Re: Lu Project – Revised Wetland Buffer Modification Plan Review

Re: SAR16-02993 Lu Wetland Buffer Modification

PROPOSED 10265 RESIDENCE
10265 124TH AVE NE, KIRKLAND 98033

Re: **SAR16-02993**
10265 124th Ave NE
Buffer Modification & Piped Stormwater Outfall
Code Section KZC90.34.3

DRAINAGE/BMP PLAN

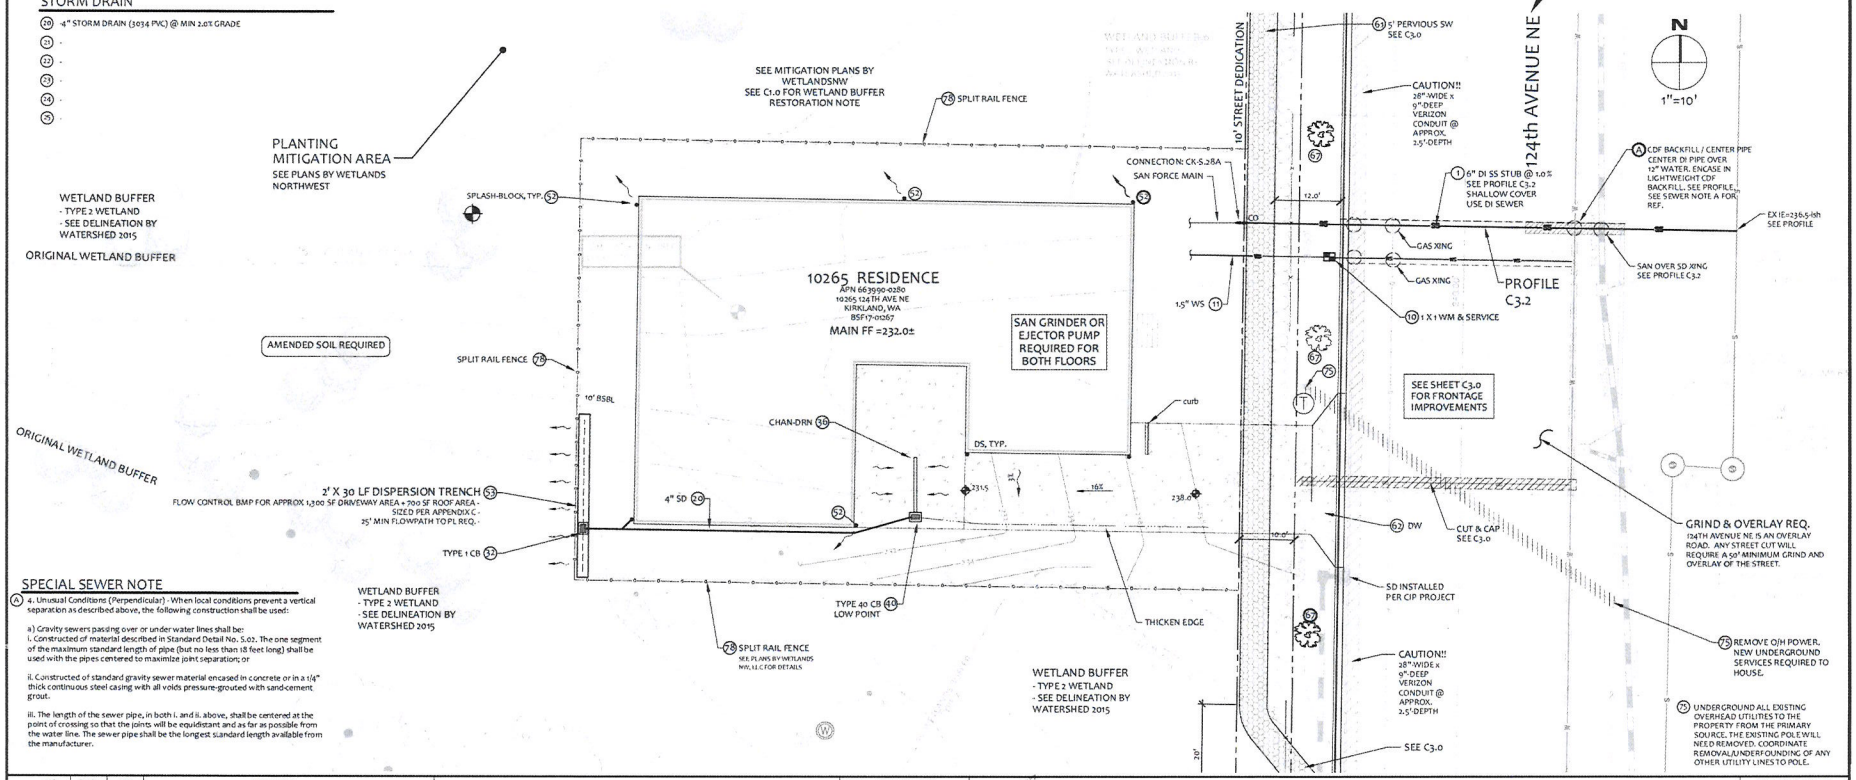
1. The civil engineering plans, prepared by Civil Engineering Solutions, have not been revised to reflect the new mitigation planting area. **Recommendation**: Since the planting plan is much more extensive than previously shown, all project plans should be consistent to avoid future confusion.

Item 1:
The civil engineering plans, prepared by Civil Engineering Solutions, have not been revised to reflect the new mitigation planting area. Recommendation: Since the planting plan is much more extensive than previously shown, all project plans should be consistent to avoid future confusion.

Response: The engineer's civil/drainage sheet now shows the planting mitigation in the background as advised. See Attached Civil Plans.

DEVELOPMENT PROPOSAL & BUFFER MITIGATION
SITE PLAN
KING COUNTY TAX PARCEL NO.: 663990-0280

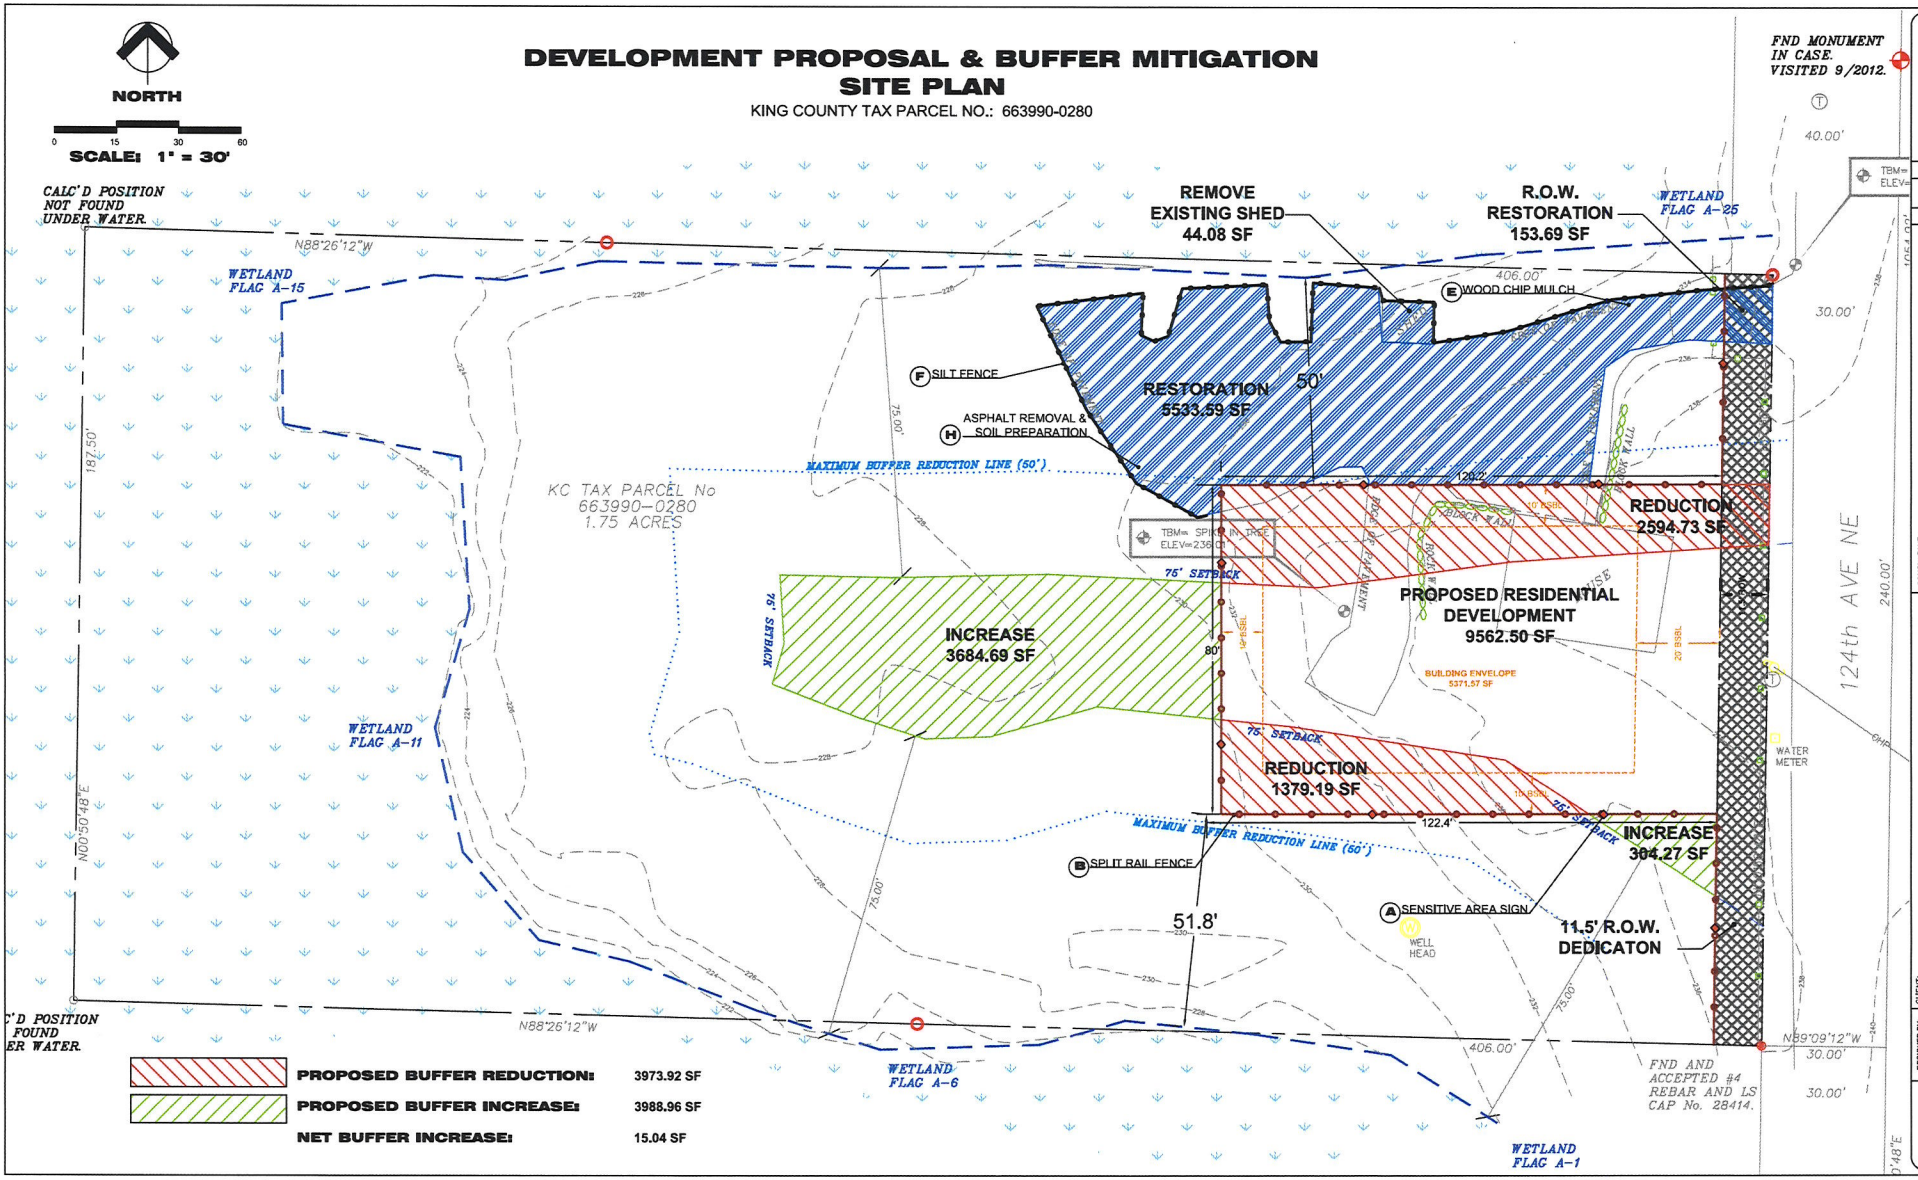
3. The revised planting plan showing additional plantings around the house are generally acceptable with one exception. The plants do not change in the vicinity of the three proposed stormwater outfalls. **Recommendation:** Revise the planting plan to include more stormwater-tolerant species in the vicinity of stormwater dispersal areas.

Item 3:
The revised planting plan showing additional plantings around the house are generally acceptable with one exception. The plants do not change in the vicinity of the three proposed stormwater outfalls. Recommendation: Revise the planting plan to include more stormwater-tolerant species in the vicinity of stormwater dispersal areas.

Response: See revised Buffer Mitigation plan attached with this submission dated 10/23/2017.

FIGURE C.2.1.A TYPICAL SPLASH BLOCK

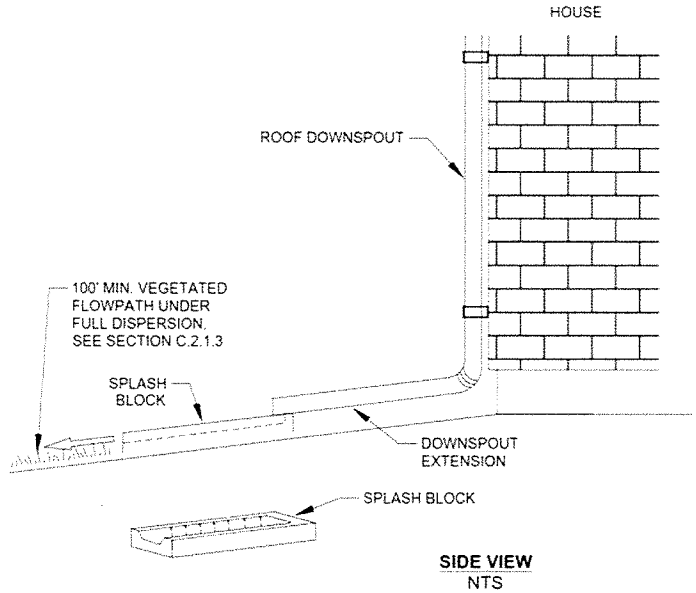
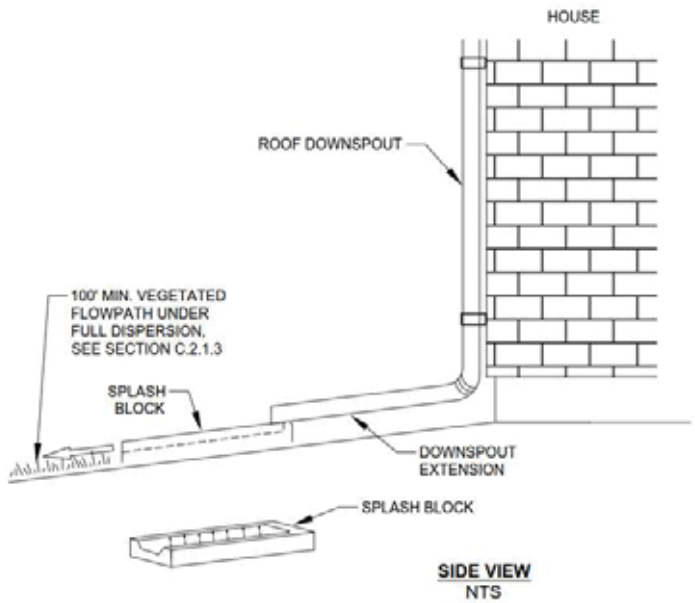
2. The Wetlands Northwest letter describes an infiltration trench at the southwest corner of the proposed residence. The letter does not describe a splash block at the northwest house corner and an unspecified outfall type at the reduced buffer edge draining via a 4" pipe from the north edge of the driveway. These elements are shown on the civil plans. KZC 90 allows stormwater outfalls within buffer setbacks only when it can be satisfactorily shown the outfalls meet certain requirements and criteria. The revision does not address these criteria. **Recommendation:** The civil plans should provide more detail on the 4-inch pipe outfalling towards the wetland buffer; specifically, how will this water be dispersed? The applicant should also provide a narrative outlining how the proposed outfalls meet the requirements and criteria found in 90.45.3

Item 2:
The Wetlands Northwest letter describes an infiltration trench at the southwest corner of the proposed residence. The letter does not describe a splash block at the northwest house corner and an unspecified outfall type at the reduced buffer edge draining via a 4" pipe from the north edge of the driveway. These elements are shown on the civil plans. KZC 90 allows stormwater outfalls within buffer setbacks only when it can be satisfactorily shown the outfalls meet certain requirements and criteria. The revision does not address these criteria. Recommendation: The civil plans should provide more detail on the 4-inch pipe outfalling towards the wetland buffer; specifically, how will this water be dispersed? The applicant should also provide a narrative outlining how the proposed outfalls meet the requirements and criteria found in 90.45.3.

Response from Engineer: "Splashblocks inherently have no impact. I would never characterize a roof downspout to a Splashblock as an outfall. Splashblocks inherently disperse the roof water to the surrounding area. These are considered low impact and simple, low cost and elegant forms of dispersion. It's too bad we can't use them more often in the urban areas. The tributary roof area is only 0.01 acre (700 sf). Outfall should be used to characterize much larger basins with bigger diameter storm systems.

The infiltration trench located at SW corner reference is actually a dispersion trench. They look the same as infiltration and are shallow rock filled trenches but dispersion has a level spreader "header" at surface in case the trench fills with water and it will then disperse evenly across it's length. Pretty low impact bmp also."

See attached Splashblock Detail
